Item Name: Crosstube Assembly, Mid Fwd

DART AEROSPACE LTD	Work Order:	132348
Description: Crosstube Assembly, Mid Fwd	Part Number:	D206-667-147
Inspection Dwg: D206-667-147 Rev: A		Page 1 of 2

DART AEROSPACE LTD HAWKESBURY, ONTARIO, CANADA	
DRAWING NO. D206-667-147	REV. A SHEET 1 OF 4
TITLE CROSSTUBE ASSY (206L MID FWD)	SCALE NTS

DRAWING NO. D206-667-147	TITLE CROSSTUBE ASS'Y (206L MID-FWD)	REV. A	DART AEROSPACE LTD ENGINEERING ORDER		D.E.O. NO. D206-667-147-A-1	SHEET NO. SHEET 1 OF 1	SCALE NTS
DRAWN 90	CHECKED ASS	MFG. APPR. [Signature]	APPROVED [Signature]		DE APPR. [Signature]		
DATE 11.07.15	DATE 11.07.20	DATE 11.07.21	DATE 11/07/21		DATE 11.07.21

DETAIL P
BONDING STRAP INSTALLATION 2 PL

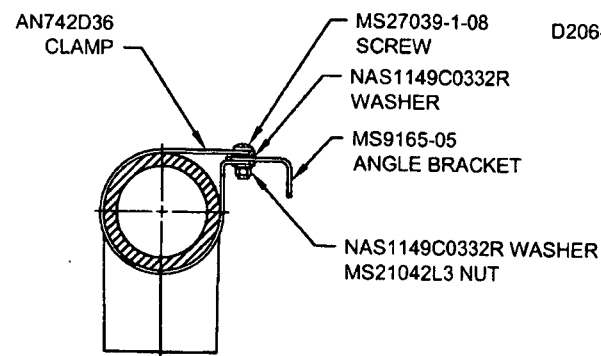
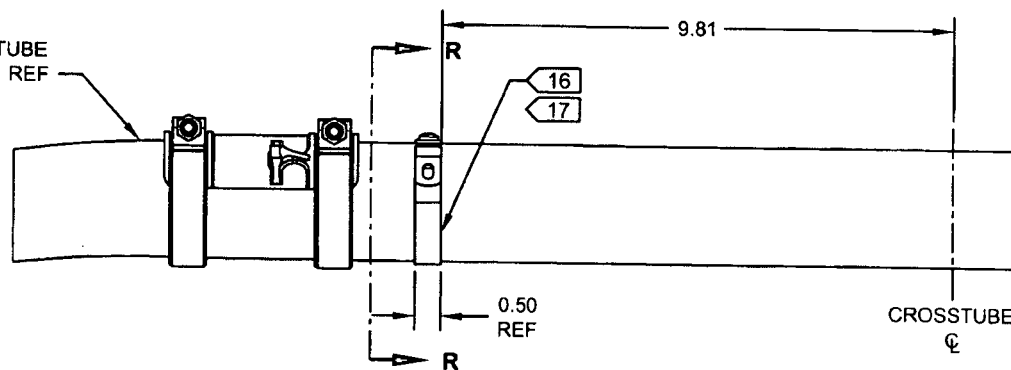
PURPOSE:

ADD ELECTRICAL GROUNDING STRAP

- 16) MASK AREA UNDER CLAMP PRIOR TO PAINTING
- 17) SEAL EDGES WHERE AN742D36 CLAMP MEETS WITH THE CROSSTUBE USING SIKAFLEX-241/-291 OR MIL-S-8802 CLASS B2 OR PROSEAL 890 SEALANT
- 18) PERFORM RESISTANCE CHECK TO ENSURE MAX RESISTANCE IS 10 MILLIOHMS

ITEM	QTY -147	PART NUMBER	DESCRIPTION
1	X	D206-667-147	CROSSTUBE ASSEMBLY (206L MID FWD)
10	2	AN742D36	CLAMP
11	2	MS9165-05	ANGLE BRACKET
12	2	MS21042L3	NUT (OR MS21042-3)
13	2	MS27039-1-08	SCREW
14	4	NAS1149C0332R	WASHER (OR AN960C10L)
